NMP1L3070

Nine Mile Point Nuclear Station, Units 1 and 2
Renewed Facility Operating License Nos. DPR-63 and NPF-69
NRC Docket Nos. 50-220 and 50-410

Subject: License Amendment Request – Reactivity Anomalies Surveillance

PROPOSED TECHNICAL SPECIFICATION and BASES MARKED-UP PAGES

SR 3.1.2.1

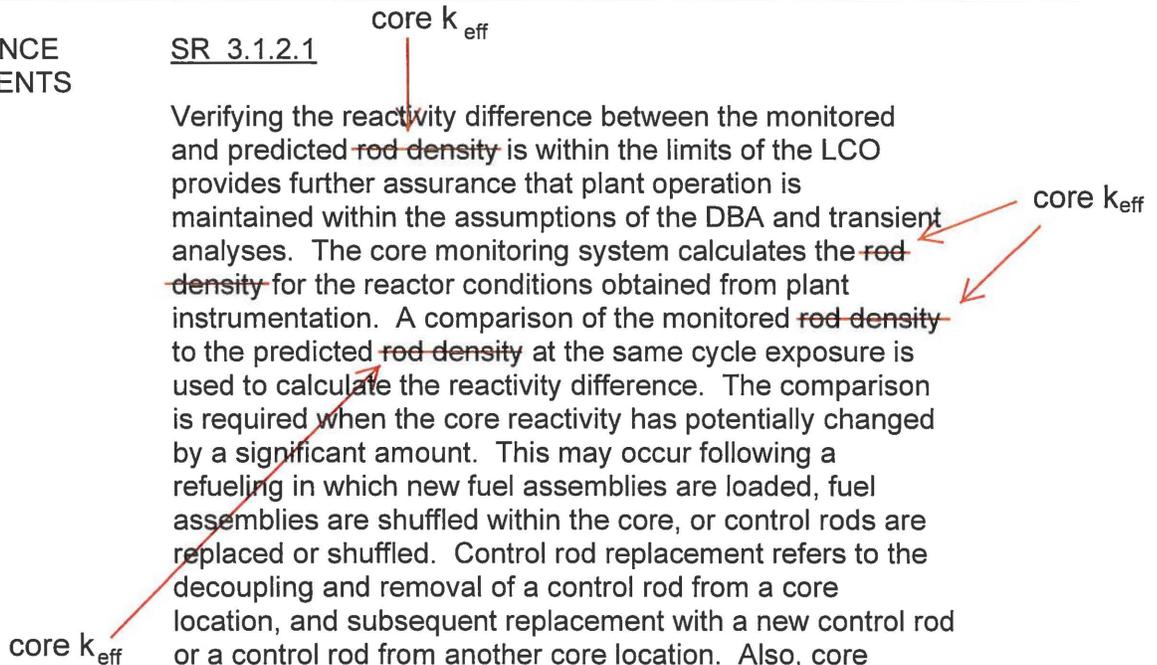
Verifying the reactivity difference between the monitored and predicted ~~rod density~~ is within the limits of the LCO provides further assurance that plant operation is maintained within the assumptions of the DBA and transient analyses. The core monitoring system calculates the ~~rod density~~ for the reactor conditions obtained from plant instrumentation. A comparison of the monitored ~~rod density~~ to the predicted ~~rod density~~ at the same cycle exposure is used to calculate the reactivity difference. The comparison is required when the core reactivity has potentially changed by a significant amount. This may occur following a refueling in which new fuel assemblies are loaded, fuel assemblies are shuffled within the core, or control rods are replaced or shuffled. Control rod replacement refers to the decoupling and removal of a control rod from a core location, and subsequent replacement with a new control rod or a control rod from another core location. Also, core reactivity changes during the cycle. The 24 hour interval after reaching equilibrium conditions following a startup is

SR 3.1.2.1 (continued) core k_{eff}
